# Access Compliance Report

## Public Rights-of-Way

### (Curb Ramps)

Intersection ID: 11295	Main Street: AVENTIDE_LN	Cross Street: CHANTRESS_LN	Location: NE
ADA ID: 880DD4980165	Ramp Type: BlendTrans1	Initial Pass/Fail: Fail	Overall Compliance: No
		Severity Score: 8.75

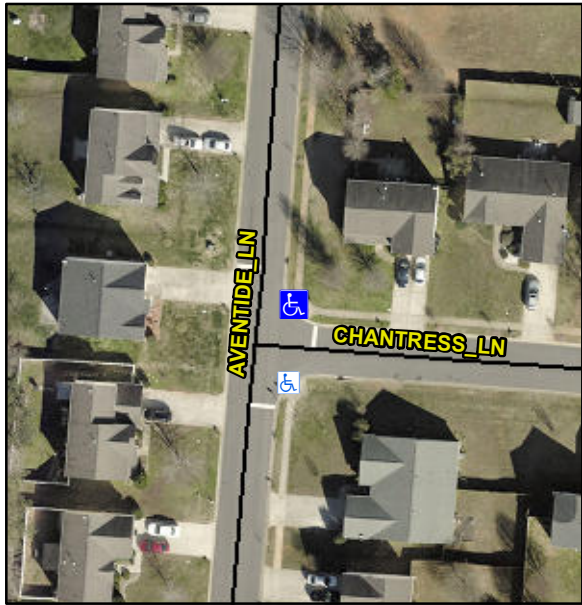
**CURB LIP 0.5**

**Not Found, R304.5.1**

**Remove & Replace Curb Ramp With Two New Directional Ramps or Equivalent.**
